**SOLICITATION AMENDMENT
MODIFICATION DE L'INVITATION**

Title - Sujet Second Floor Fit-up - GOCB	
Solicitation No. - N° de l'invitation EV385-183075/A	Amendment No. - N° modif. 003
Client Reference No. - N° de référence du client PWGSC EV385-183075	Date 2018-04-03
GETS Reference No. - N° de référence de SEAG PW-\$PWU-004-11337	
File No. - N° de dossier PWU-7-40256 (004)	CCC No./N° CCC - FMS No./N° VME
Solicitation Closes - L'invitation prend fin at - à 02:00 PM on - le 2018-04-11	Time Zone Fuseau horaire Mountain Daylight Saving Time MDT
F.O.B. - F.A.B. Plant-Usine: <input type="checkbox"/> Destination: <input type="checkbox"/> Other-Autre: <input type="checkbox"/>	
Address Enquiries to: - Adresser toutes questions à: Espedido, Karielen K.	Buyer Id - Id de l'acheteur pwu004
Telephone No. - N° de téléphone (780) 497-3859 ()	FAX No. - N° de FAX (780) 497-3510
Destination - of Goods, Services, and Construction: Destination - des biens, services et construction: PWGSC GOCB 2nd Floor, 101 22nd Street East Saskatoon, SK

AMENDMENT #003:

ADDENDUM #003:

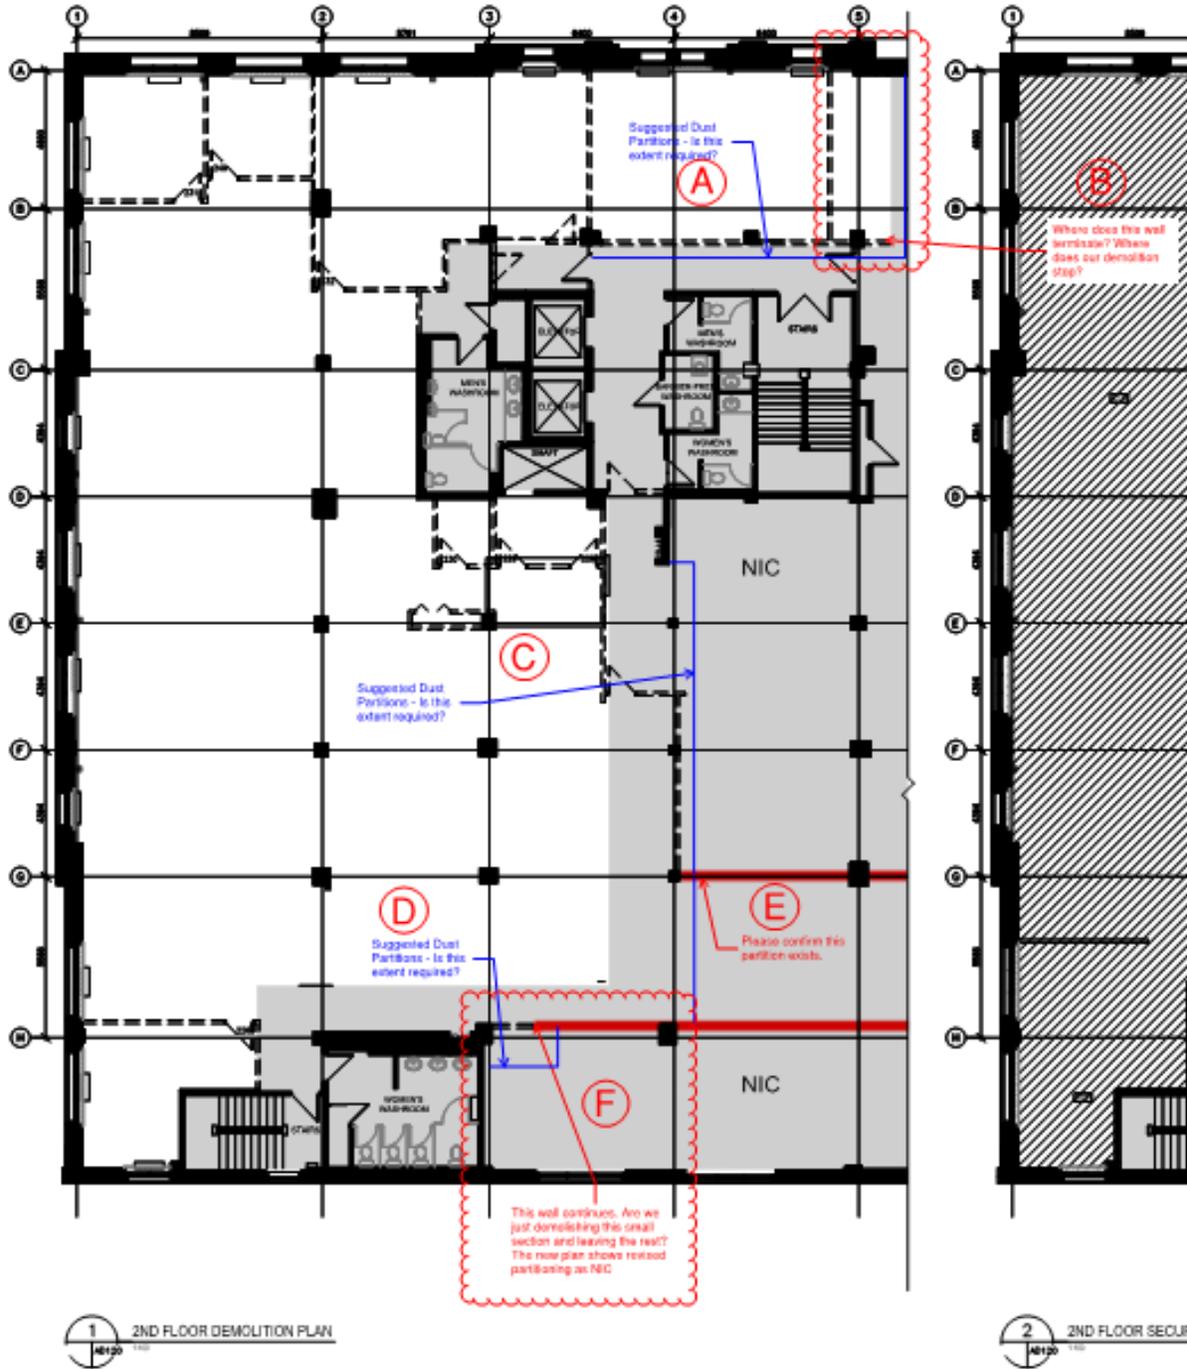
Q9 Drawing AD120, 2nd Floor Demolition Plan: Plan doesn't appear to illustrate all of the existing partitions. Can this be revised? This will help in establishing the amount of dust containment required as some existing walls can be utilized as a barrier. See attached.

- A. Suggested Dust Partitions - Is this extent required?
Answer: Contractor to determine the method of meeting or exceeding the requirements in Section 01 14 00 Work Restrictions, for the project construction.

- B. Where does this wall terminate? Where does our demolition stop?
Answer: The wall terminates at the column located at grid line 5 near grid line B. The demolition would stop at this column as well.

- C. Suggested Dust Partitions - Is this extent required?
Answer: Contractor to determine the method of meeting or exceeding the requirements in Section 01 14 00 Work Restrictions, for the project construction. Note that the relocation of the dust-proof barriers will be required as the work progresses in the public corridor parallel with grid line 4.

- D. Suggested Dust Partitions - Is this extent required?
Answer: This area is outside the project's scope of work.
- E. Please confirm this partition exists.

Answer: The partition exists, however it is outside the project's scope of work. Stop demolition at column located at gridlines 4 and G.
- F. This wall continues. Are we just demolishing this small section and leaving the rest?
The new plan shows revised partitioning as NIC.

A9 Drawing will not be revised at this time. The following questions A through F are shown in the plan image below.

Answer: This area is outside the project's scope of work.

1. Ed2.1 – Second Floor – Demolition Plan:

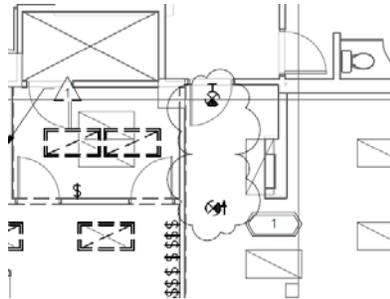
- A. Change: the 2 existing exit signage shown outside of room 217A to be demolished.

2. EL2.1 – Second Floor – Lighting Plan:

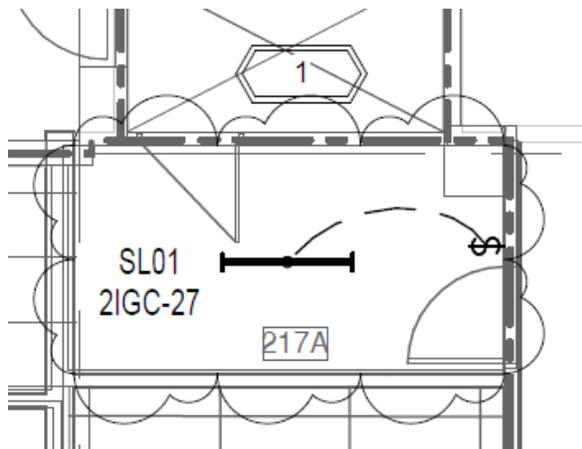
- a. Change: provide 1 lighting fixture type 'SL01' in room 217A to be suspended mounted c/w manual toggle switch by door, circuit to 2IGC-27. Coordinate with mechanical diffuser location. Type 'SL01' to be 4' LED strip frosted diffuser c/w wireguard, 3000 lumens, 3500k, 80 cri, Lithonia ZL1N-L46-3000LM-FST-MVOLT-35K-80CRI-WH-WGZ48 or approved equal.

- B. Clarify: lighting fixture in Room 227 to be aligned with architectural ceiling grid.

3. EP2.1 – Second Floor – Power & Systems Plan:

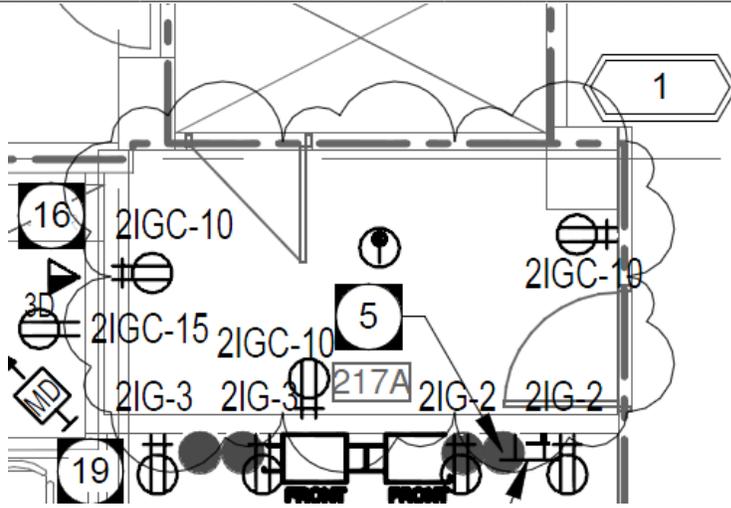
- A. Change: add 3 5-20R receptacles to room 217A, circuit to 2IGC-10 with 20a/1p breaker.
B. Change: add 1 heat detector to Room 217A.
